Validation Report

VALIDATION OF THE CDM-PROJECT:
METHANE RECOVERY IN WASTEWATER TREAT-
MENT, PROJECT AMA07-W-01, PERAK, MALAYSIA

REPORT NO. 1026968

May 29, 2008

Figure 2

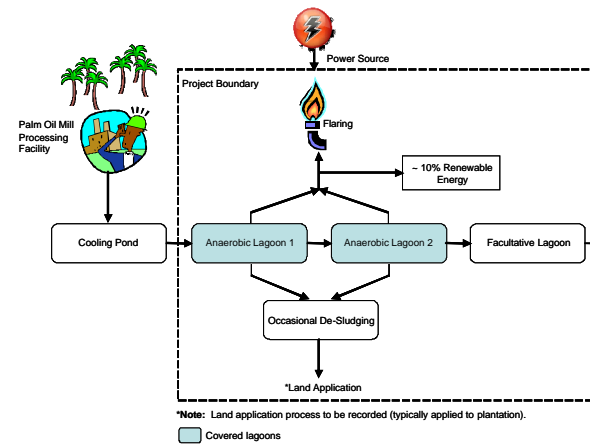
In the PDD, Figure 2 essentially reflects the idea of a clearly defined project boundary including the two biodigesters (two anaerobic lagoons) and the occasional de-sludging. The facility will recover the 100% of the methane emitted from the two anaerobic lagoons instead of recovering only 60% of three lagoons (CAR6, CR9, CR8, CAR7, CAR9, CAR8, and CR7).

two lagoons are converted.	
<p><u>Corrective Action Request No.8.</u></p> <p>Project boundary is not correctly described in the figure 2 project boundary of page 11. The project boundary should include the occasional de-sludging. The final disposition of sludge monitoring is required by the methodology and it is part of the project boundary. Please correct the diagram.</p>	B.3.2	<p>The project boundary diagram has been updated to reflect that occasional de-sludging and sludge monitoring (disposition) are part of the project boundary (see diagram CAR #7).</p>	<p>The latest version of the PDD reflects the diagram updated where the occasional de-sludging is included within the project boundary.</p> <p style="text-align: center;">p</p>
<p><u>Corrective Action Request No.9.</u></p> <p>The PDD describes a flexible project boundary that can cover any number of lagoons that facilitate the capture of between 60-100% of total methane generated and does not specify the total number of existing lagoons capable of generating methane. Such a vague description is not acceptable as the project boundary dictates the calculation of the emission reduction that can be achieved and consequently the judgment on whether the emission reduction cap of 60 kT CO₂e can be met. Further, the site visit revealed that a decision on how many lagoons are to be equipped with methane capture/combustion systems is yet to be reached. Please define the project boundary based on the exact number of lagoons to which methane capture/combustion systems are to be applied.</p>	B.3.2	<p>The project scenario will be changed to reflect a digester modification of ONLY the first two (anaerobic) lagoons. These two lagoons will have both biogas capture and combustion equipment. The third lagoon, which is facultative, will not be converted into a biodigester.</p> <p>The 3rd lagoon will be retained in the project boundary in case it becomes necessary to add either procedures and/or equipment to ensure this lagoon stays facultative. If any equipment is added, full records will be maintained (including electricity requirements).</p> <p>(see diagram, CAR #7)</p>	<p>The project boundary is clearly defined and describe in the latest version of the PDD.</p> <p>With the exclusion of the possible further installation of a cover in the third lagoon there is not risk of exceeding the 60 Kt CO₂e.</p> <p style="text-align: center;">p</p>
